# Access Compliance Report

## Public Rights-of-Way

Intersection ID: 29501	Main Street: REDDMAN_RD	Cross Street: SOUTHWOOD_OAKS_LN	Location: NE
ADA ID: B4FF4556C128	Ramp Type: PerpDiag	Initial Pass/Fail: Fail	Overall Compliance: No
		Severity Score: 25

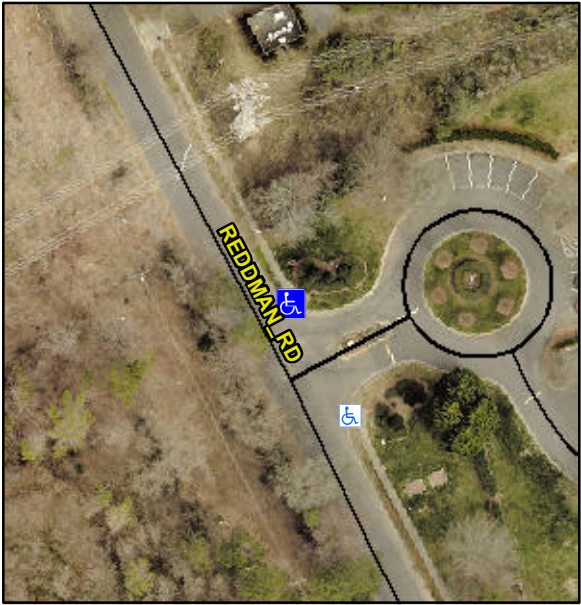
Codes/Mitigation Info/Possible Solution			Field Measurements/Component Compliance		
	Possible Solutions:		<b>Compliance</b>	<b>Description</b>	<b>Data</b>
	<b>Remove &amp; Replace Curb Ramp With Two New Directional Ramps or Equivalent.</b>		N/A	Ramp Length (in)	45.0
			Yes	Ramp Width (in)	48.0
			N/A	Flare Type LT	N/A
			N/A	Flare Slope LT (%)	N/A
			N/A	Flare Traversable LT?	N/A
			N/A	Landing Length (in)	N/A
			N/A	Landing Width (in)	N/A
			N/A	Landing Slope (%)	N/A
			N/A	Landing X Slope (%)	N/A
<p>Surveyor Notes:</p> <p><b>N/A</b></p> <p>PROW/ADA:</p> <p><b>Not Found, R304.2.2, R304.5.3</b></p>			N/A	Flare Type RT	N/A
			N/A	Flare Slope RT (%)	N/A
			N/A	Flare Traversable RT?	N/A
			N/A	DWS Provided?	N/A
			N/A	DWS Contrast?	N/A
			N/A	DWS Length (in)	N/A
			N/A	DWS Full Width?	N/A
			N/A	DWS Offset (in)	N/A
			N/A	Shared Landing?	N/A
			N/A	Gutter Ponding?	N/A
			N/A	Gutter Lip Ht (in)	N/A
			N/A	Painted X Walk1?	No

X Walk 1 Direction	To W
			N/A	X Walk 1 Width (in)	N/A
				X Walk 1 Slope (%)	0.8
				X Walk 1 X Slope (%)	3.8
			N/A	Ramp inside XWalk1?	N/A
				Road Slope (%)	3.0
				Road X Slope (%)	0.9
			N/A	Any Obstructions?	N/A
				Obstruction Type	
					N/A
					N/A
					N/A
					N/A
					N/A
					N/A
					N/A
					N/A
					N/A
					N/A
			Yes	Surface Condition? (G/P)	Good
